ECN/PCN No.: 4330

| For Manufacturer | | |
|---|--|--|
| Product Description: LOW ESR, LOW CL CERAMIC SMD CRYSTAL | Abracon Part Number / Part Series: ABM8W | <input type="checkbox"/> Documentation only <input checked="" type="checkbox"/> Series <input checked="" type="checkbox"/> ECN <input type="checkbox"/> Part Number <input type="checkbox"/> EOL |
| Affected Revision: B | New Revision: C | Application: <input type="checkbox"/> Safety <input checked="" type="checkbox"/> Non-Safety |

Mechanical dimensions:

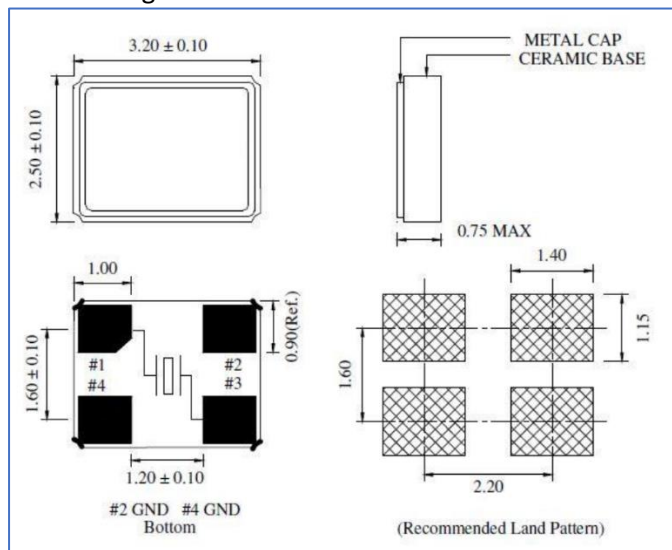
Prior to Change:

- Height= 0.75mm MAX

Mechanical dimensions:

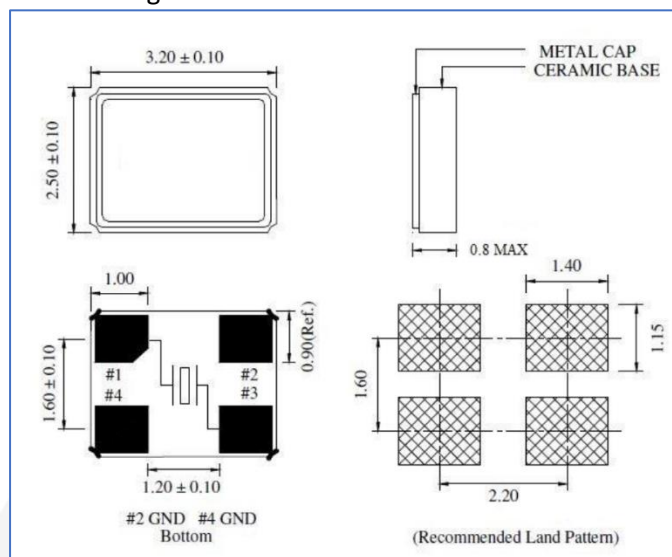
After Change:

- Height= 0.80mm MAX

Abracon introduced additional manufacturing sources to ensure product availability and to be in a better position to meet long term customer demand. Updated mechanical dimensions to reflect the product produced by all manufacturing sources.

| Change Plan | | |
|--|--|---|
| Change Declaration: The package mechanical dimension revision do not impact the recommended landing pattern nor the electrical performance of the device. | | |

Mechanical Dimensions

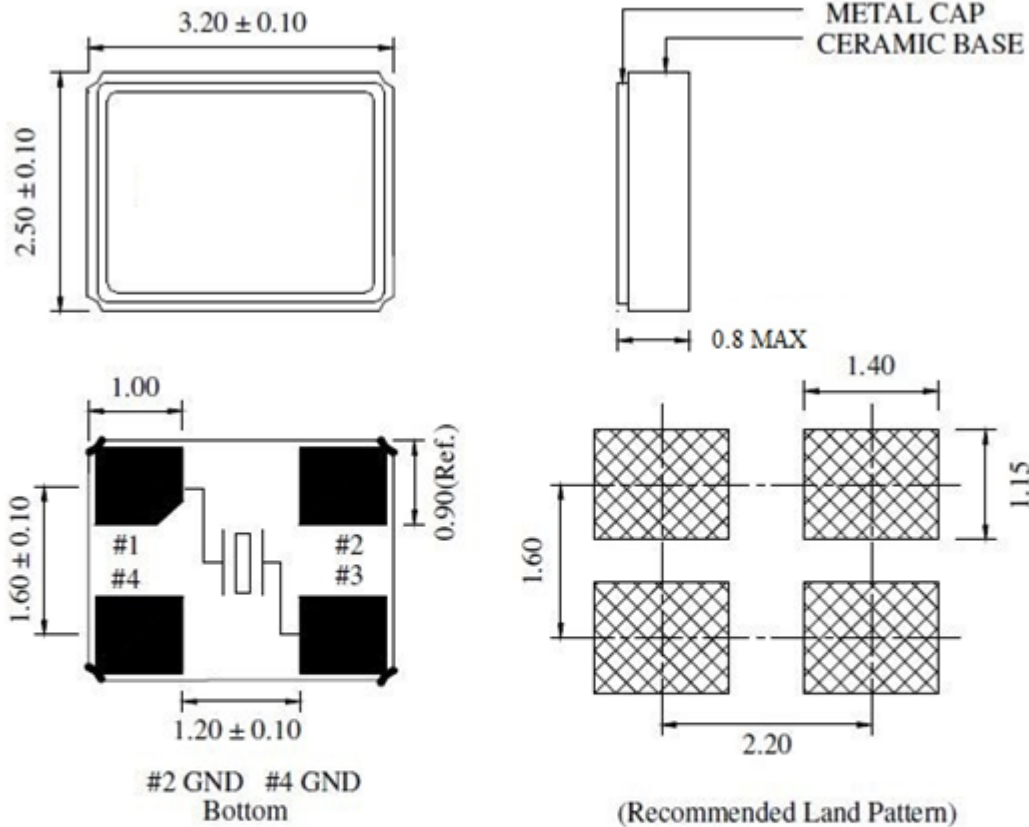
Due to material availability the Chamfer could be located on pin #1, 2 or 4. Be advised that the Chamfer location has no impact on the electrical performance of the device.
